Access Compliance Report

Public Rights-of-Way

(Curb Ramps)

Intersection ID: 49931	Main Street: WOBURN_RD	Cross Street: ASHBOURNE_HALL_RD	Location: SW
ADA ID: 7F0C019AE06A	Ramp Type: Perp	Initial Pass/Fail: Fail	Overall Compliance: No
Severity Score: 25			
Codes/Mitigation Info/Possible Solution		Field Measurements/Component Compliance

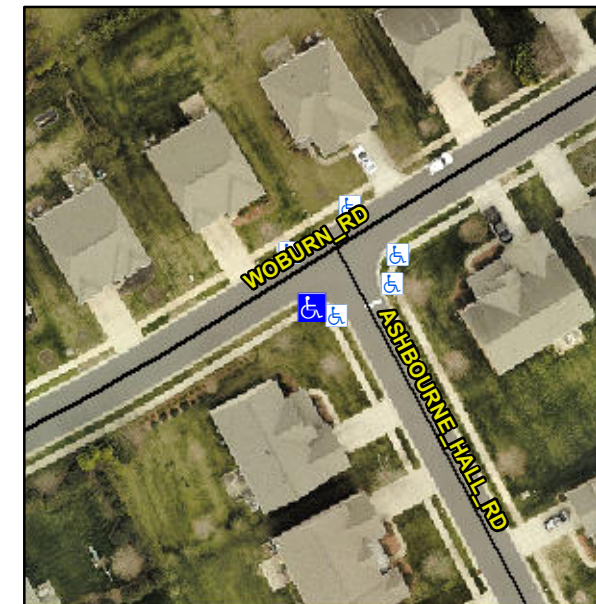
PROW/ADA:

Not Found, R304.5.3

Compliance	Description	Data	Compliance	Description	Data
N/A	Ramp Length (in)	47.0	Yes	Ramp Slope (%)	7.5
Yes	Ramp Width (in)	48.0	No	Ramp XSlope (%)	7.8
N/A	Flare Type LT	N/A	N/A	Flare Type RT	N/A
N/A	Flare Slope LT (%)	N/A	N/A	Flare Slope RT (%)	N/A
N/A	Flare Traversable LT?	N/A	N/A	Flare Traversable RT?	N/A
N/A	Landing Length (in)	N/A	N/A	DWS Provided?	N/A
N/A	Landing Width (in)	N/A	N/A	DWS Contrast?	N/A
N/A	Landing Slope (%)	N/A	N/A	DWS Length (in)	N/A
N/A	Landing X Slope (%)	N/A	N/A	DWS Full Width?	N/A
N/A	Landing Curb? (Y/N)	N/A	N/A	DWS Offset (in)	N/A
N/A	Shared Landing?	N/A			
N/A	Gutter Ponding?	N/A	N/A	Gutter Slope (%)	N/A
N/A	Gutter Lip Ht (in)	N/A	N/A	Gutter X Slope (%)	N/A
N/A	Painted X Walk1?	No	N/A	Painted X Walk2?	N/A
	X Walk 1 Direction	To NW		X Walk 2 Direction	N/A
N/A	X Walk 1 Width (in)	N/A	N/A	X Walk 2 Width (in)	N/A
	X Walk 1 Slope (%)	2.6		X Walk 2 Slope (%)	N/A
	X Walk 1 X Slope (%)	4.9		X Walk 2 X Slope (%)	N/A

Possible Solutions:

Remove & Replace Entire Ramp.
